Our Ref: 19-2099.04

Thank you for your response regarding the planning application for Brockhampton West, Harts Farm Way, Havant Site (reference: APP/21/00189 dated 17 August 2021). For ease of reference, we have included the Agency's comments in red italics, with our specific response to the issues raised following:

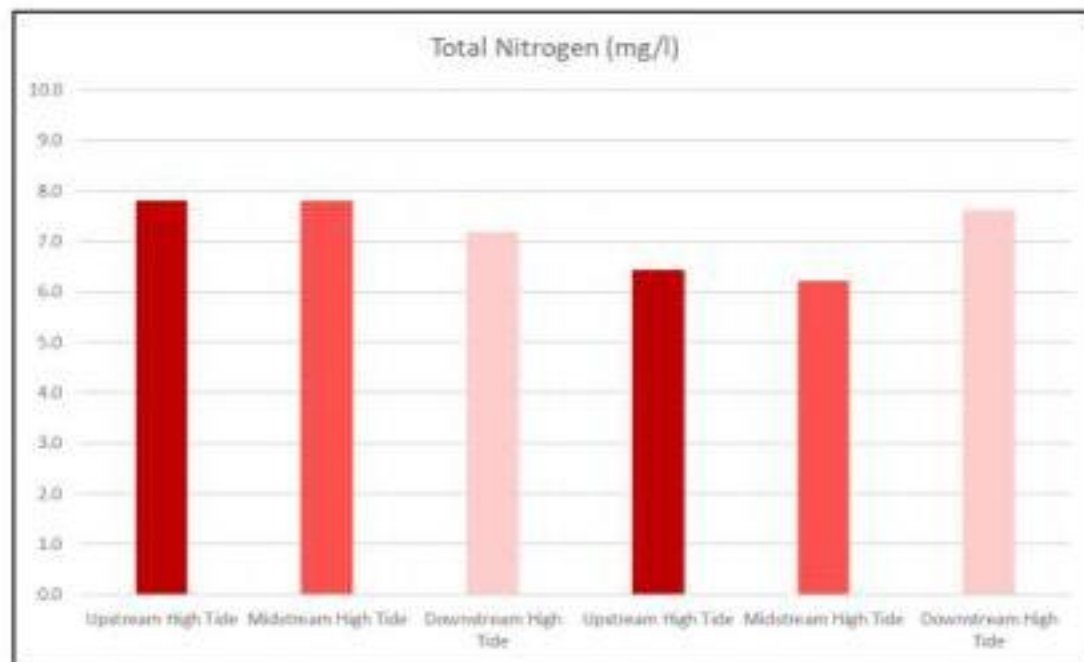
“There are comments indicating that elevated Nitrites were observed in the stream, but it has been assumed to be from offsite sources due to a lack of Nitrite being observed on site. Nitrites often occur as a transformation product from Ammonium in aerobic environments. There is as such a clear significant source of any observed Nitrites associated with this site. Therefore, any elevated Nitrites should be subject to further assessment.

We remain concerned regarding the impact of Nitrogen species on the wider environment. We agree that the observation from the Hermitage Stream does indicate that there is significant attenuation of Ammonium. This may be both from dilution and oxidation. These may vary dependent of factors such as flow and temperature. However Nitrites, and the wider environmental loading from Nitrates, remain a concern.”

We have assessed the Total Nitrogen in all species (both mineralised and oxidised) for the surface water sampling events. Concentrations for the high-tide sampling events are illustrated on the graph overleaf (note that the graph reflects the data from two separate sampling events):

There is no discernible or statistically significant change in nitrogen concentrations upstream / downstream of the Site. This is with the possible exception of the 'Downstream' high tide concentration in the second visit. This visit was undertaken after a period of heavy rainfall. It is of note that this sampling point is within circa 200m of a Consented stormwater discharge point from Budds Farm Wastewater Treatment Works. It is possible that this discharge was occurring at the time of sampling and, due to the rising tide, resulted in slightly higher nitrogen concentrations.
